12.3 Radiation Protection Design Features

The information in this section of the reference ABWR DCD, including all subsections, tables, and figures, is incorporated by reference with the following departures and supplements.

Figure 12.3-74 Upper Drywell Shielding Radiation Dose Rates with Fuel Bundle on Refueling Bellows (Gy/h)

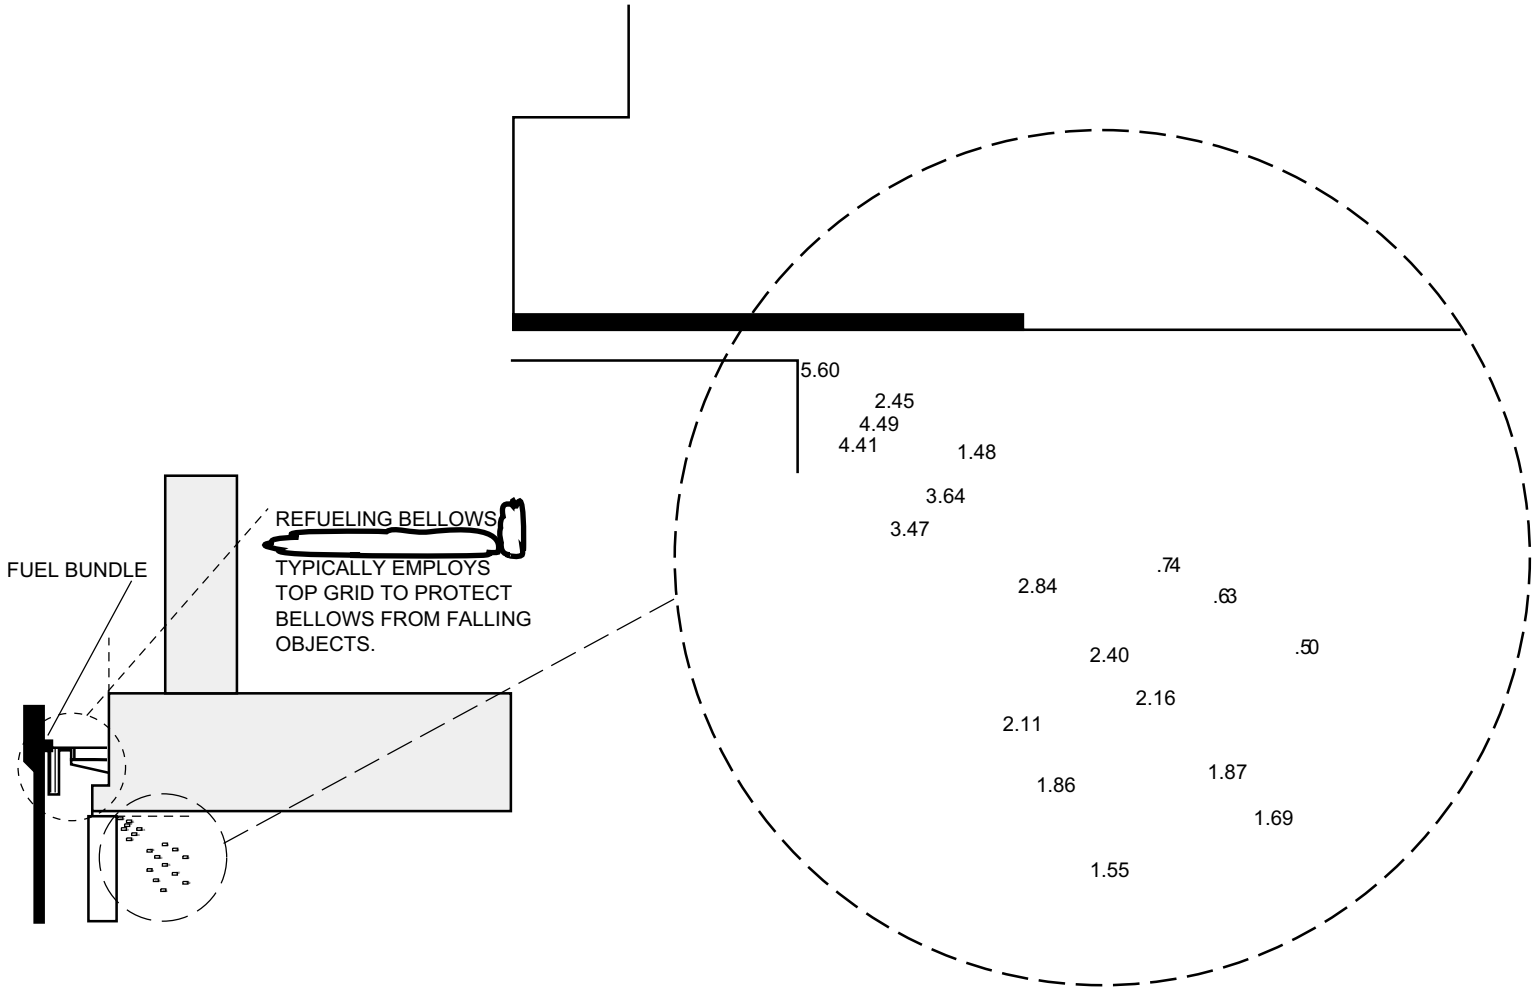
STD DEP Admin (Figures 12.3-1, 12.3-3, 12.3-6 and 12.3-74)
